COMMENTS AND RESPONSE REPORT

THE PROPOSED EXPANSION OF MILKWOOD MANOR HOUSE AND PARKING ON ERF 10190, REMAINDER OF ERF 2066 AND REMAINDER OF ERF 706, PLETTENBERG BAY, WESTERN CAPE

Figure 3 depicting the damage of the September 2023 storm event with the wooden decks, furniture and balustrade completely destroyed

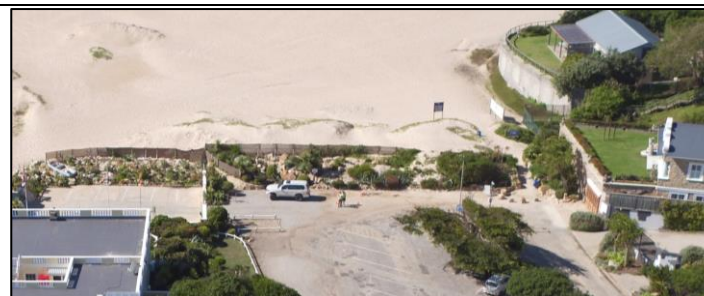
2.1.11. In terms of the location of the proposed wooden deck and public showers, although this would be a public benefit, recent storm events have shown how destructive these storm events can be especially to wooden decks. The September 2023 coastal storm surge destroyed the wooden decking of the Ficks Pool restaurant in Hermanus despite the location of the restaurant within in a sheltered bay as well its very elevated position – see Figure 2 below. As such, in terms of public safety, the SD: CM does not support any such infrastructure. There is also no clarity as to who will be liable for such infrastructure since it is proposed to be located on CPP.

We do not believe that the proposed wooden deck and shower would place public safety at risk, we do not argue that a storm surge could in fact wash the structure up onto the car park however in such an event there will in all likely hood not be anyone making use of the facility, the destruction would carry a financial burden either on the developer or municipality to repair the facility or at the very least remove the demolished structure.

Additionally, it will be far safer, more logical and convenient for the public to que and use a beach shower located just on the beach instead of in the car park which could prove dangerous for the families waiting to use the shower. Motorists will be trying to find parking and could be distracted instead of keeping a keen eye out for kids running around. We believe it's in the public's safety to keep the beach shower away from the carpark.

Due to other negative comments relating to the beach shower and ablution block the preferred alternative has been revised to exclude

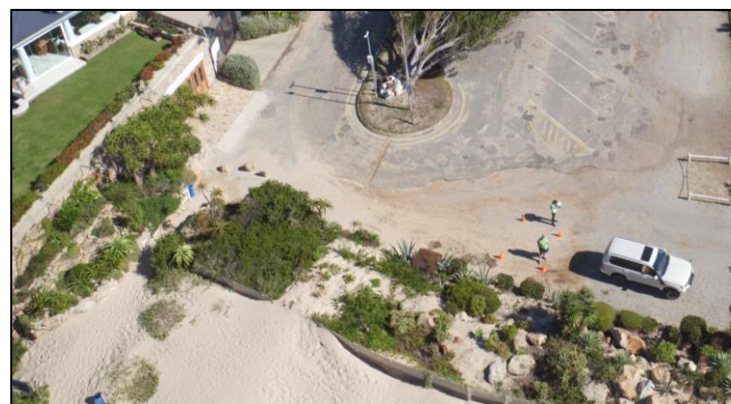
2.1.12. The proposed wooden deck and public showers seems to be located within the littoral active zone ('LAZ'). Any activities within this area that does not support natural coastal processes may result in erosion. The NEM: ICMA regards the LAZ to be a dynamic system where the free movement of sand must not be interfered with. It is essential that the competent authority not only considers the impact(s) the proposal and its associated activities will have on the receiving environment, but also the impact(s) that environment, including dynamic coastal processes would have on the proposed wooden deck and public showers.

We do understand the apprehension for the placement of the showers in the LAZ, however when looking at the proposed area holistically and taking the images below of the site into consideration one can conclude that the location of the site is in fact located in a wind shadow created by the surrounding landscape and structure. Deposition of sand mainly occurs at this location so instead of erosion there will be more of a maintenance requirement to keep the shower deck clear of sand periodically.

Additional, as mentioned in our previous response, the LAZ will not be compromised, and the public will be far safer showering on the beach instead of in the carpark.

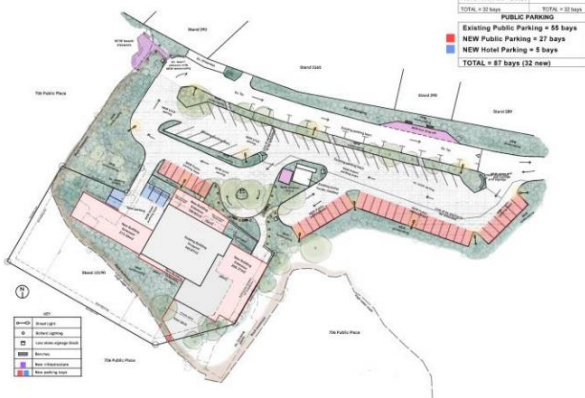
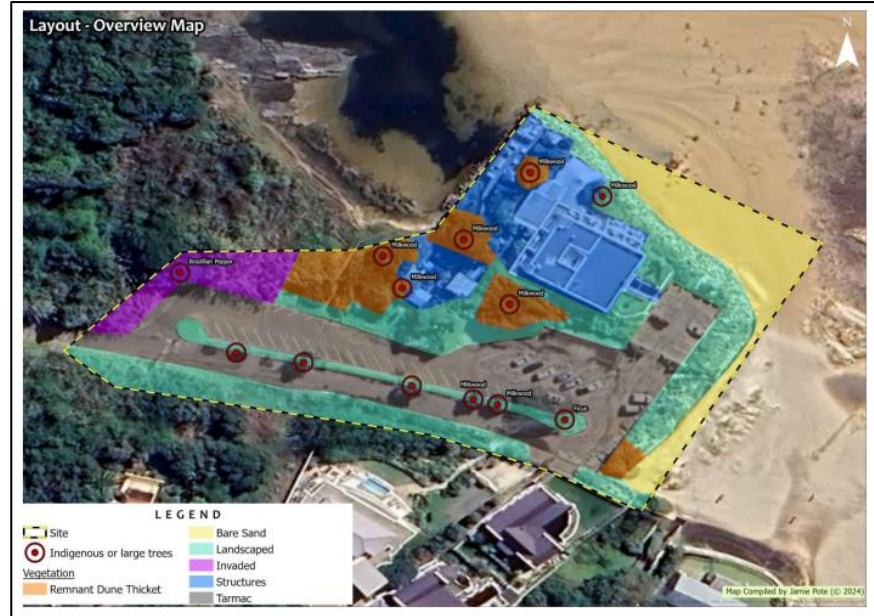
<p>buildings as well as construction of both internal and public parking bays and public ablution facilities to service visitors to the adjacent public beach; the existing ground floor of the building is 563.87 m² and the existing first floor is 401.91m²</p> <p>It is proposed to add new rooms, a reception, a bar, a transport area and pergola to the ground floor increasing the total ground floor to 1112.97 m²- Upgrades to the first floor includes new rooms, a store and a spa increasing the total first floor to 957.98m²- This will bring the total floor area of the new hotel to approx. 2,071m²; To accommodate the expansion of the guest house, the existing parking lot must also be expanded- 1.25 parking bays is required for every room in the hotel-30 parking bays is required; Currently Lookout Beach has no public amenities such as toilets and showers- Part of the proposal is to provide these facilities for the public's benefit- The new ablution block will be located adjacent to the existing municipal pump station on Remainder of Erf 2066 " According to the report- "The property consists of Milkwood trees; As well as a small pocket of Coastal forest at the beach access point- which includes a few individuals of species including <i>Tarchonanthus littoralis</i>, <i>Carpobrotus acinaciformis</i>, <i>Eriocephalus paniculatus</i>, <i>Helichrysum patulum</i>, <i>Selago burchellii</i>, <i>Stenotaphrum secundatum</i>, <i>Azima tetraacantha</i>, <i>Carissa bispinosa</i>, <i>Euclea racemosa</i>, <i>Grewia occidentalis</i>, <i>Metalasia muricata</i>, <i>Scutia myrtina</i>, <i>Searsia crenata</i>, <i>Cynanchum viminalis</i> & <i>Cynanchum ellipticum</i>"</p>

<p>It appears that most of the Milkwoods will be retained however one is located within one of the proposed new parking spots and a NFA application may be required. Greater clarity regarding the actual on-site placement of the parking spot in relation to the tree will be obtained once the site footprint is marked out and the site has been surveyed.</p>	
Indigenous forest as well as protected trees are protected under the National Forest Act (NFA) (Act No. 84 of 1998) as amended.			91
This letter is not a NFA licence.		This is understood.	92
Forestry reserves the right to revise initial comment based on any additional information that may be received			93

<p>PUBLIC PARKING</p> <p>Existing Public Parking = 55 bays NEW Public Parking = 27 bays NEW Hotel Parking = 8 bays TOTAL = 87 bays (32 new)</p>	REQUIRED	PROPOSED	7.75 hectares	8 hectares	100 spaces	100 spaces	10000 m²	10000 m²	TOTAL = 100 spaces	TOTAL = 100 spaces			
REQUIRED	PROPOSED												
7.75 hectares	8 hectares												
100 spaces	100 spaces												
10000 m²	10000 m²												
TOTAL = 100 spaces	TOTAL = 100 spaces												
Forestry request that the proposed extensions- as well as the proposed layout incorporate the protected trees. Protected trees to be retained and indicated as no-go areas		A National Forestry Act Licence application will be undertaken before these trees are disturbed.	90										
		The terrestrial biodiversity specialist has mapped the protected Milkwoods on site and as seen in the combined layout with potential trees below, Milkwoods will have to be removed to undertake the expansion. The specialist has assessed the removal of the trees and found that these remnant Milkwood trees do not perform any substantial ecosystem service and will not have any significant impact to the broader conservation of the species

The protected trees are also present on both site development plans.
